# UNITED STATES PATENT AND TRADEMARK OFFICE

APPLICATION NO.	FILING DATE	FIRST NAMED INVENTOR	ATTORNEY DOCKET NO.	CONFIRMATION NO.
10/615,146	07/08/2003	Thomas Kuckelkorn	2678	8229
7590 04/13/2005 STRIKER, STRIKER & STENBY 103 East Neck Road Huntington, NY 11743			EXAMINER PRICE, CARL D	
			ART UNIT 3749	PAPER NUMBER

# Office Action Summary

## DETAILED ACTION

Figure 4 of US004231353 (KANATANI et al) shows:

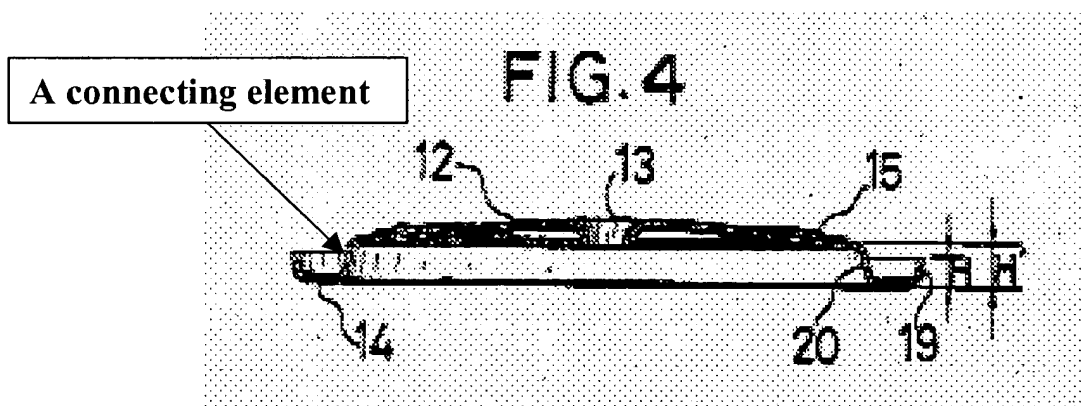
In regard to claims 44, 45, 57 and 58, US004231353 (KANATANI et al) shows (Figure 4) and discloses:

- the interior end (not referenced) of the folding bellows (15) is connected with the glass sleeve tube (9) by a connecting element (20; see annotated figure 4 herein below) and by the glass-metal transitional element (19).
